# City of Santa Fe, New Mexico

# memo

**2025-011105-HDRB, 128 Camino Santiago, Downtown & Eastside Historic District,** contributing, John Padilla, agent for Josh Gonzales, owner, proposes an amendment to case 2023-007678-HDRB by constructing a 162 sq. ft. portal to a height of 10'-6" where the maximum allowable height is 13'-3", replace windows and doors, and other alterations, Exceptions are requested to 14-5.2(D)(5)(a) for replacing historic windows on a primary façade, 14-5.2(D)(2)(d) for constructing an addition within 10' of the primary façade, and 14-5.2(D)(2)(d) to exceed 50% of the historic footprint.

Figure 3: Window Schedule

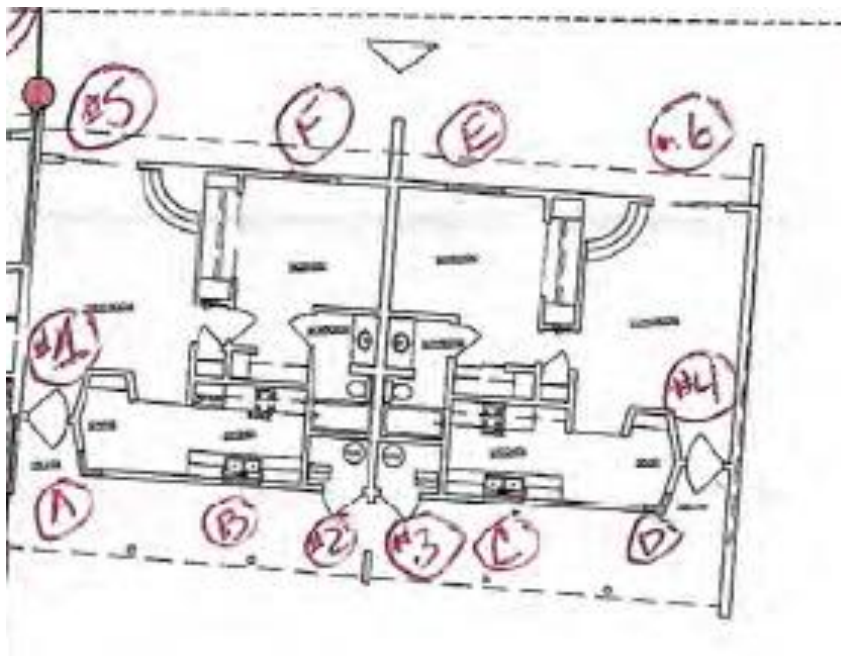
1. Replace windows and doors and enclose windows on the primary façade. New windows and doors will be a metal-clad exterior finish (Sierra Pacific, or equal) with the primary façade window replacements, with no change in size. The proposed windows are undivided double-pane. An exception is requested to 14-5.2(D)(5)(a) for replacing historic windows on a primary façade. The previously approved window and door changes include the infill of doors on the north facade at the far east (1), and two center mechanical doors (2 and 3), and the replacement of the two corner windows (A and D). This request is to replace the other windows B and C.

Staff recommends denial of the windows.

The proposed windows are undivided double-pane windows where there are currently divided lite windows. As part of the previous case, the board did request that these additional windows be repaired rather than replaced. Furthermore, there was a condition that those who were approved be sympathetic to the existing doors and windows with the same lite pattern, thin muntins, and thin frames. The currently proposed muntin pattern, or lack thereof, does not replicate the historic material and style.

Staff Response: Staff find that this criterion is not met. The historic windows are in satisfactory condition and can continue to serve the residence, streetscape, and historic district as long as they are maintained.

Staff Response: Staff finds that this criterion is not met. According to the window assessment rating, these historic windows are in satisfactory condition and, therefore, are repairable at this time. There is no hardship in retaining the windows.

Staff Response: Staff find that this criterion is not met. These windows were discussed at the previous hearing, and it was the understanding of the HDRB and staff that they would be retained if the HDRB allowed the infill and replacements that it approved under the previous

case. The applicant is now again requesting the replacement of the windows. Therefore, they are not looking at other options to retain these historic windows.

1. Staff finds that the exception criteria have not been met and recommends denial of the exception to 14-5.2 (D)(5)(a) for replacing historic windows on a primary façade.
2. Staff finds that the exception criteria have not been met and recommends denial of the exception to 14-5.2(D)(2)(d) for constructing an addition within 10' of the primary façade.
